Access Compliance Report

Public Rights-of-Way

Intersection ID: 16765	Main Street: CHURCHILL_RD	Cross Street: N_WENDOVER_RD	Location: NE
ADA ID: 4F29A7680C3A	Ramp Type: BlendTrans1	Initial Pass/Fail: Fail	Overall Compliance: No
		Severity Score: 10

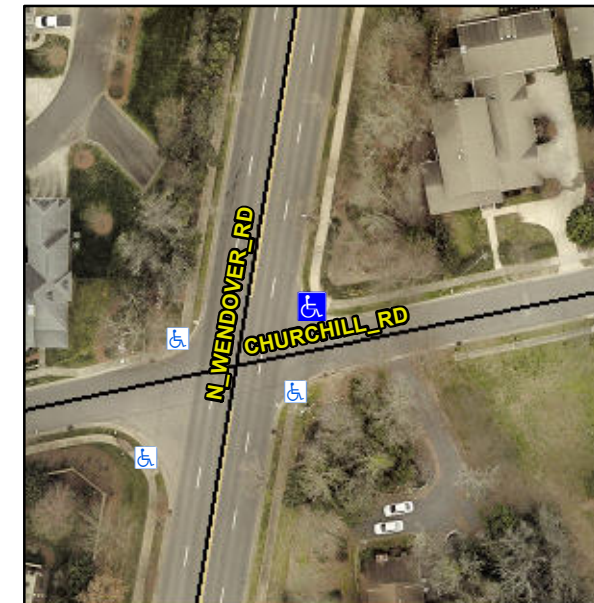
Not Found, R304.5.1, R304.5.3

Compliance	Description	Data	Compliance	Description	Data
N/A	Ramp Length (in)	50.0	Yes	BlendTrans Slope (%)	3.7
No	Ramp Width (in)	47.0	No	BlendTrans XSlope (%)	4.2
N/A	Flare Type LT	N/A	N/A	Flare Type RT	N/A
N/A	Flare Slope LT (%)	N/A	N/A	Flare Slope RT (%)	N/A
N/A	Flare Traversable LT?	N/A	N/A	Flare Traversable RT?	N/A
N/A	Landing Length (in)	N/A	N/A	DWS Provided?	N/A
N/A	Landing Width (in)	N/A	N/A	DWS Contrast?	N/A
N/A	Landing Slope (%)	N/A	N/A	DWS Length (in)	N/A
N/A	Landing X Slope (%)	N/A	N/A	DWS Full Width?	N/A
N/A	Landing Curb? (Y/N)	N/A	N/A	DWS Offset (in)	N/A
N/A	Shared Landing?	N/A			
N/A	Gutter Ponding?	N/A	N/A	Gutter Slope (%)	N/A
N/A	Gutter Lip Ht (in)	N/A	N/A	Gutter X Slope (%)	N/A
N/A	Painted X Walk1?	No	N/A	Painted X Walk2?	No
	X Walk 1 Direction	To SW		X Walk 2 Direction	To S
	X Walk 1 Width (in)	N/A		X Walk 2 Width (in)	N/A
	X Walk 1 Slope (%)	0.9		X Walk 2 Slope (%)	6.6
	X Walk 1 X Slope (%)	4.1		X Walk 2 X Slope (%)	0.5

N/A	Ramp inside XWalk1?	N/A	N/A	Ramp inside XWalk2?	N/A
	Road Slope (%)	4.9		Clear Space?	N/A
	Road X Slope (%)	3.0	N/A	Clear Space to XWalk (in)	N/A
N/A	Any Obstructions?	N/A	N/A	Storm Grate/Utility Hazard?	N/A
	Obstruction Type			Storm Grate/Utility Type	
		N/A			N/A
			Yes	Surface Condition? (G/P)	Good
			No	Curb Slope (%)	25.4

Remove & Replace Curb Ramp With Two New Directional Ramps or Equivalent.
